RE: **Outfalls 022P and 023P Relocation Request**
Blue Creek Mine No. 1
NPDES Permit No. AL0081477
Tuscaloosa and Fayette Counties (125 and 057)

RE: Warrior Met Coal BC, LLC.
Blue Creek Mine No. 1 – AL0081477
Outfall 022 & 023 Relocation Request

NPDES PERMIT MAP
NPDES NO.: AL0081477

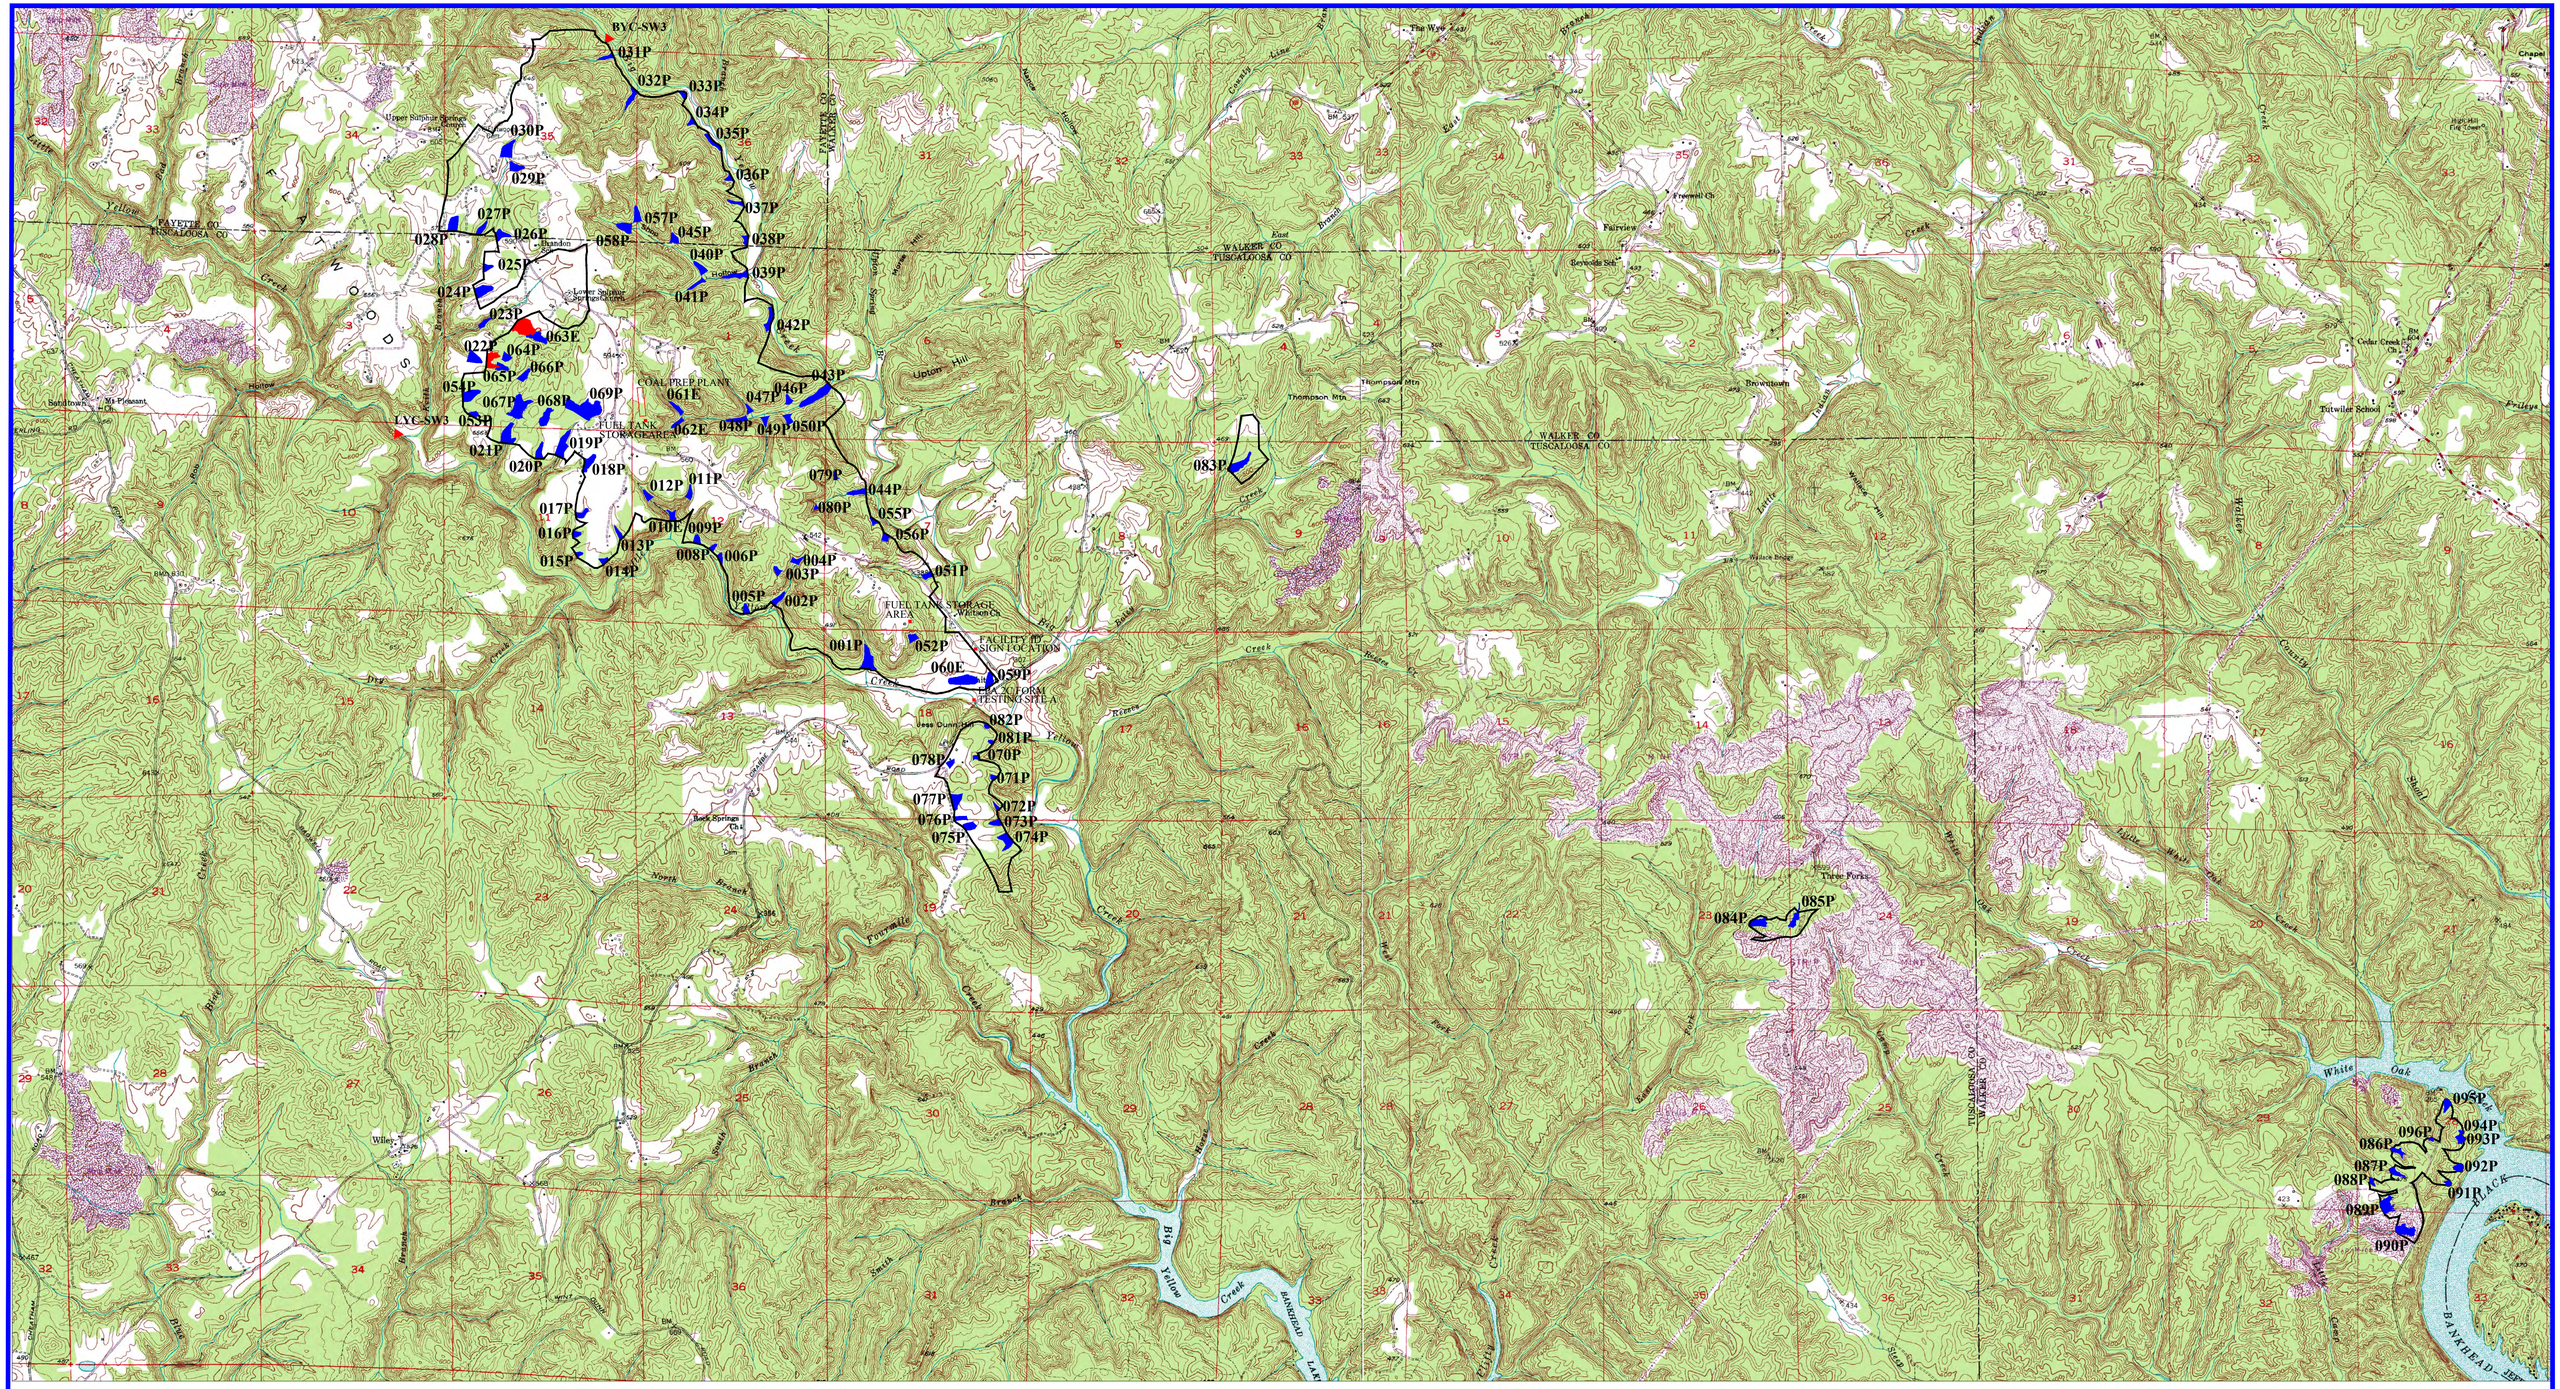
Warrior Met Coal BC, LLC, hereby requests to move outfalls 022 & 023 on the above referenced NPDES Permit. The information below lists the outfall number, permitted Lat. and Long. (in blue), and the proposed new Lat. and Long. (in red). I have also attached the 2000 scale NPDES permit map showing the permitted location (in blue) of the outfall and its proposed new location (in red).

022	Lat: 33° 35' 36" Lon: 87° 27' 19" (Proposed)
	Lat: 33° 35' 35" Lon: 87° 27' 21" (Permitted)
023	Lat: 33° 35' 46" Lon: 87° 27' 09" (Proposed)
	Lat: 33° 35' 45" Lon: 87° 27' 21" (Permitted)

Outfall 022P at its present location has a drainage area of 20 acres. Moving the outfall 540' will give it a total drainage area of 18 acres. Outfall 023P at its present location has a drainage area of 148 acres. Moving the outfall 1,540' will give it a total drainage area of 41 acres.

The Department has reviewed the document and has determined that relocation of Outfalls 022P and 023P does not require a modification of the NPDES Permit. Therefore, the request is approved.
